REPORT ON PROPOSALS

The Water Efficiency and Sanitation Standard Technical Committee
Report on Proposals for Public Review and Comment.

Date: September 23, 2025

FIGURE C 102.6(1)

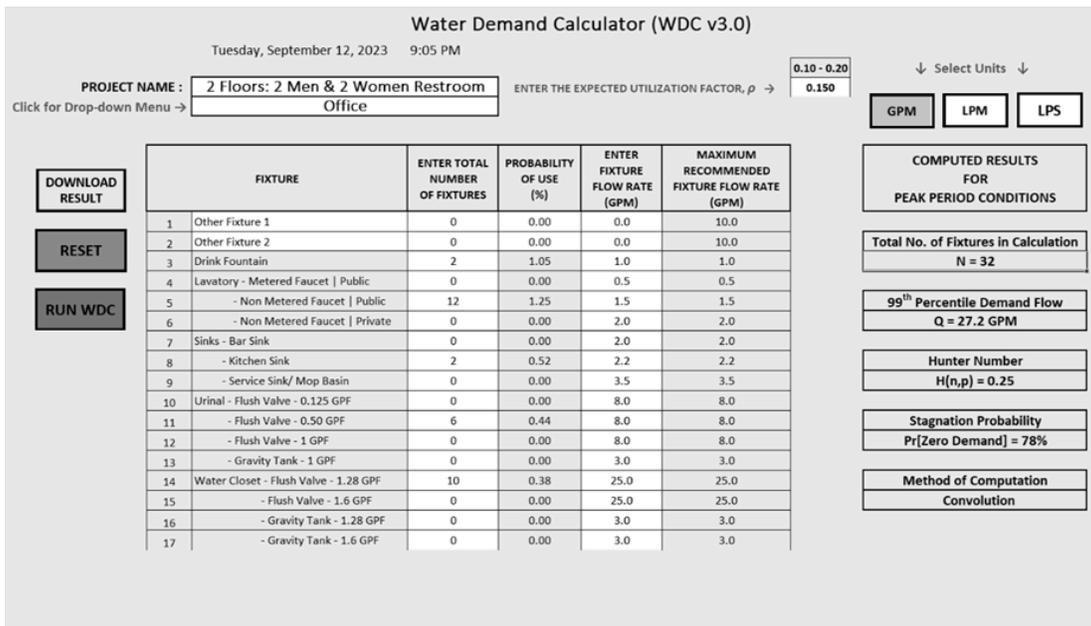
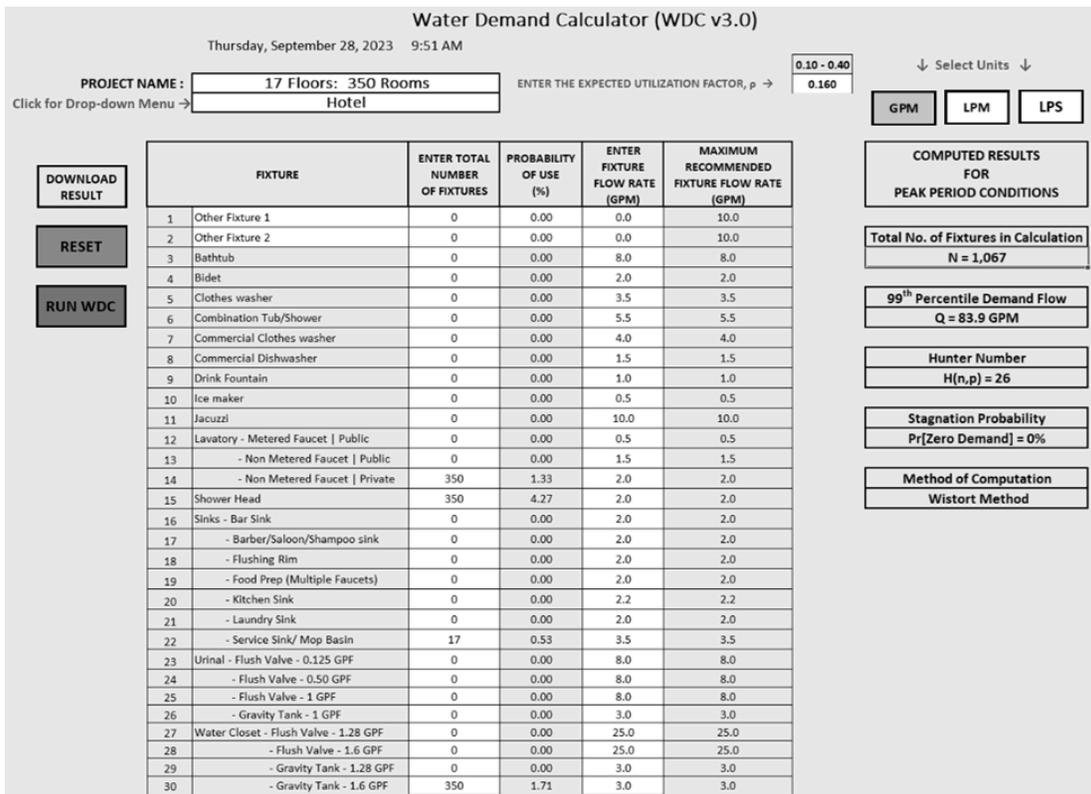
Section Number:
501.1, Table 502.1.1, Figure 502.2.1,
C 101.1, C 102.6, Figure C 102.1(2) -
Figure C 102.6(2)

OSANN: Much good work has been done here. If multi-family revisions are completed before the end of the comment period, the submitter should submit a comment that will enable the TC to take positive action.

FIGURE F 301.1(6)

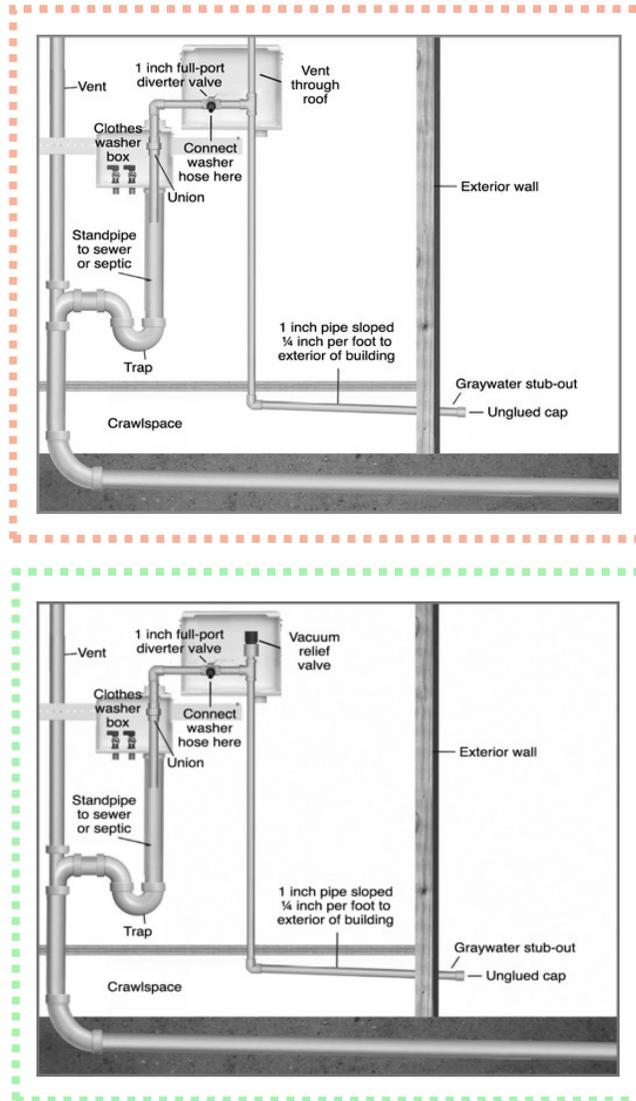
Section Number:
Figure F 301.1(6), Figure F 301.1(7)

*The union is necessary to provide access for maintenance of the standpipe and trap.

FIGURE F 301.1(7)

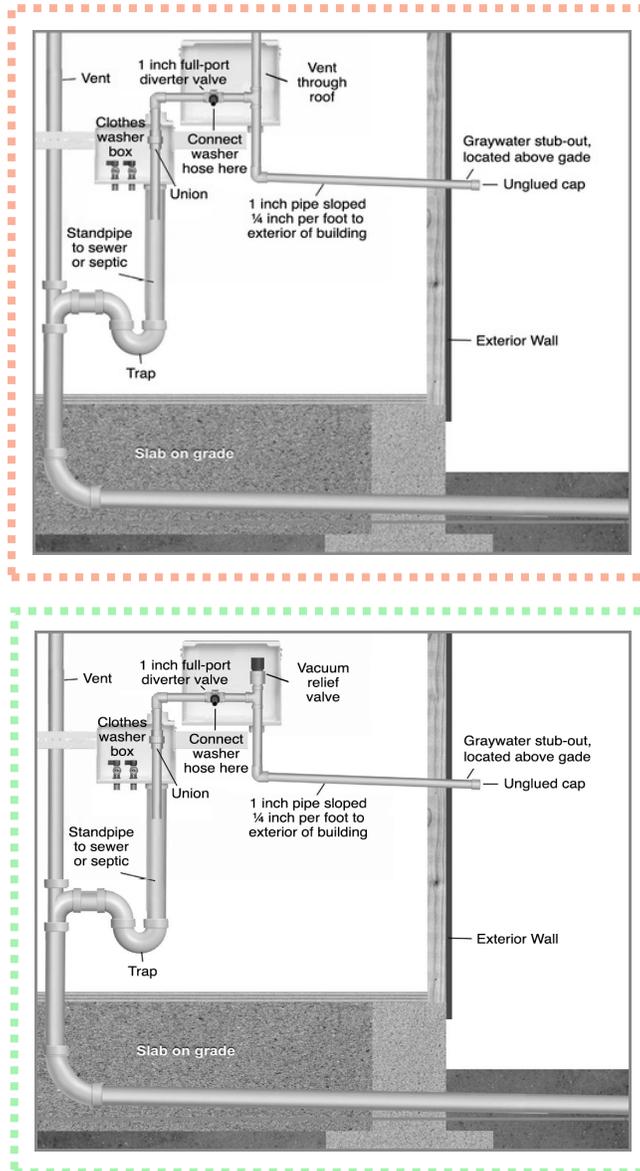
GRAY WATER DRAINAGE SYSTEM – CLOTHES WASHER GRAYWATER SYSTEM WHERE GRAYWATER IRRIGATION PIPE IS RUN THROUGH CRAWLSPACE*

FIGURE F 301.1(6)
GRAY WATER DRAINAGE SYSTEM – CLOTHES WASHER GRAYWATER SYSTEM WHERE GRAYWATER IRRIGATION PIPE IS RUN THROUGH CRAWLSPACE*

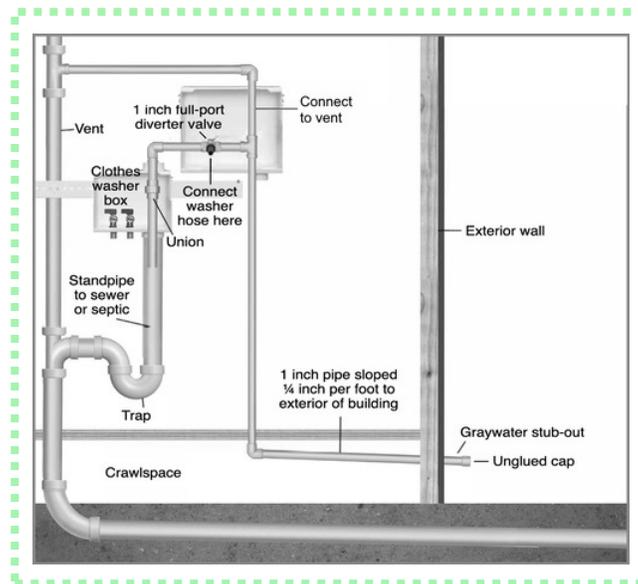
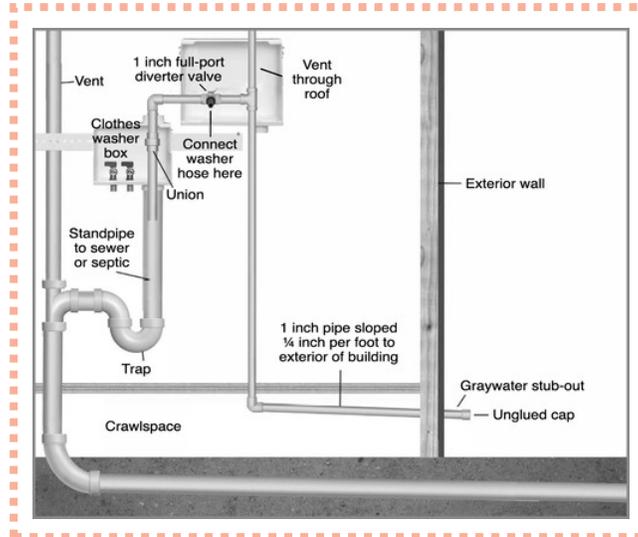
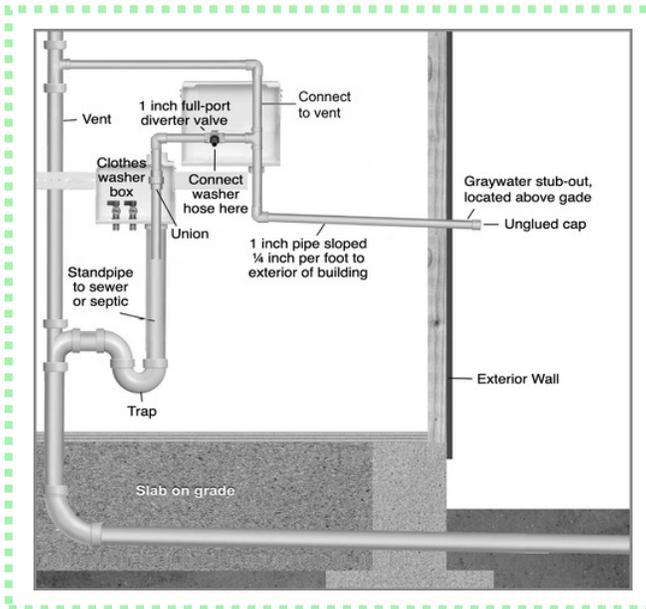
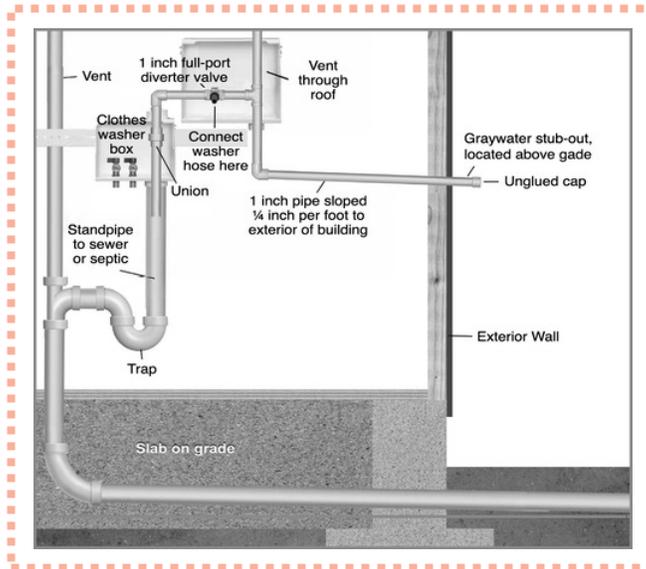
Section Number:
Figure F 301.1(6), Figure F 301.1(7)

*The union is necessary to provide access for maintenance of the standpipe and trap.
